DRAINAGE CERTIFICATION

GLENRIO APARTMENTS

PHASED GRADING PLAN

**Re: Glenrio Apartments, Phase III, Bldg. 3
6901 Glenrio Rd NW
Request for Permanent C.O. - Accepted
Engineer's Stamp dated: 5-5-14 (J10D043)
Certification dated: 3-12-15**

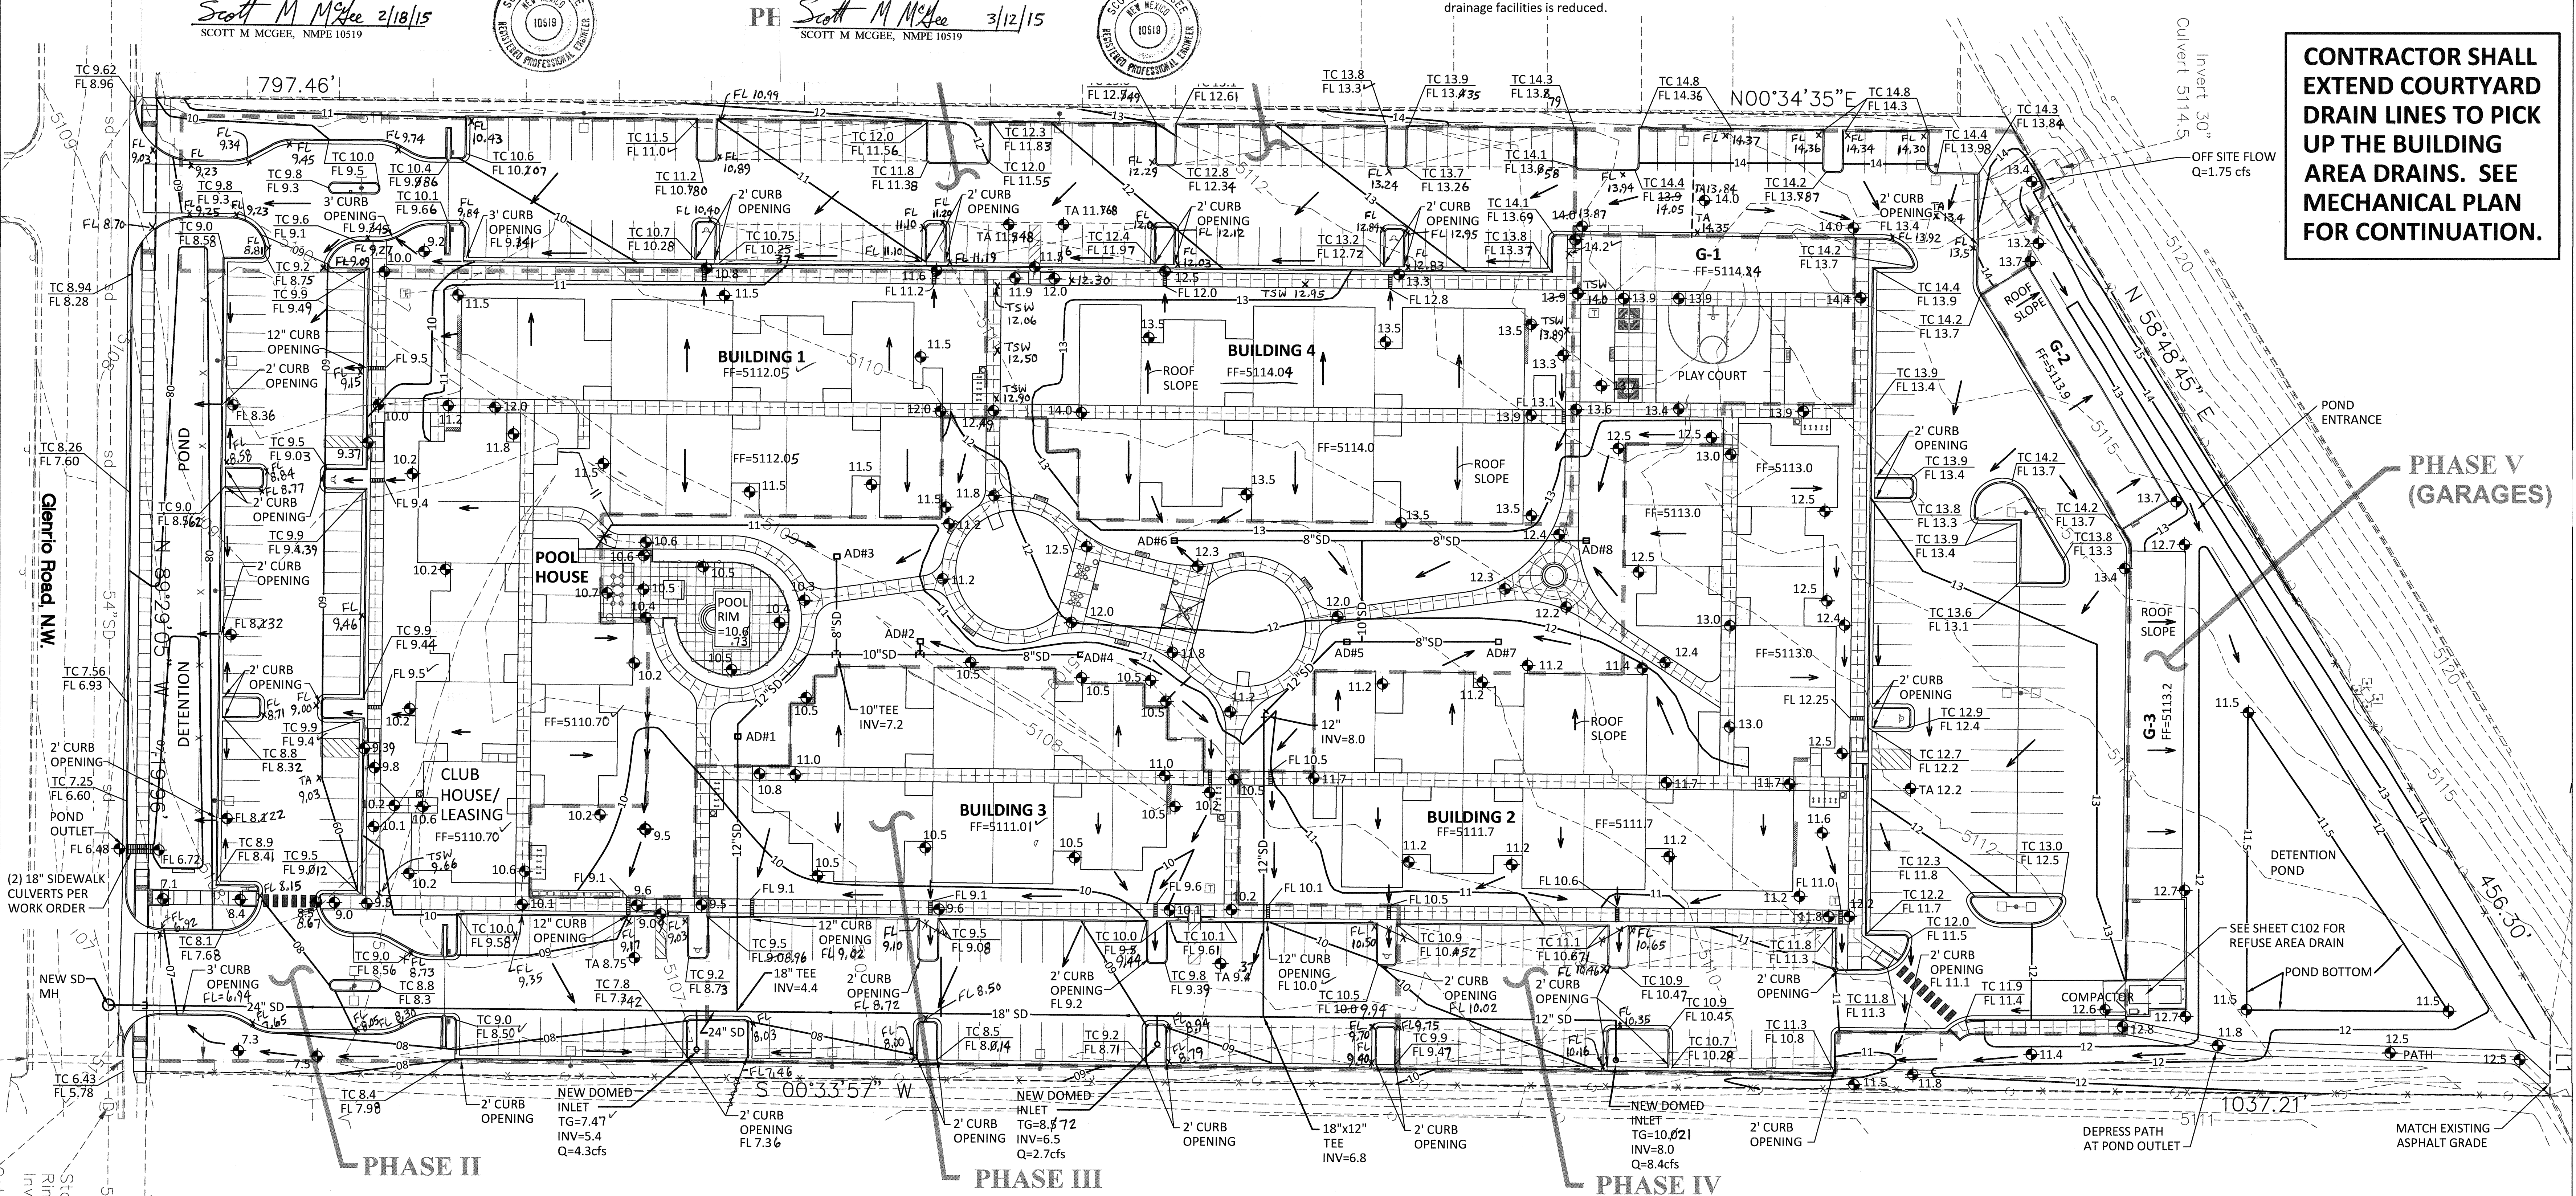
I, SCOTT M MCGEE, NMPE 10519, OF THE FIRM SCOTT M MCGEE PE, LLC, HEREBY CERTIFY THAT THIS PORTION OF THE SITE (PHASE 3), HAS BEEN GRADED AND WILL DRAIN IN SUBSTANTIAL COMPLIANCE WITH THE DESIGN INTENT OF THE APPROVED PLAN DATED 5/05/14. THE RECORD INFORMATION EDITED ONTO THE ORIGINAL PLAN HAS BEEN OBTAINED BY BRIAN MARTINEZ, NMPS 18374, OF CARTESIAN SURVEYS, INC. I ALSO CERTIFY THAT I PERSONALLY VISITED THE PROJECT SITE 3/11/15 AND HAVE DETERMINED BY VISUAL INSPECTION THAT THE SURVEY DATA PROVIDED IS REPRESENTATIVE OF ACTUAL SITE CONDITIONS AND IS TRUE AND CORRECT TO THE BEST OF MY KNOWLEDGE AND BELIEF. THIS CERTIFICATION IS SUBMITTED IN SUPPORT OF A REQUEST FOR A PERMANENT CERTIFICATE OF OCCUPANCY FOR BUILDING 3 (PHASE 3).

Based on the Certification received on 3/12/2015, the Phase III building 3 is acceptable for release of Certificate of Occupancy by Hydrology.
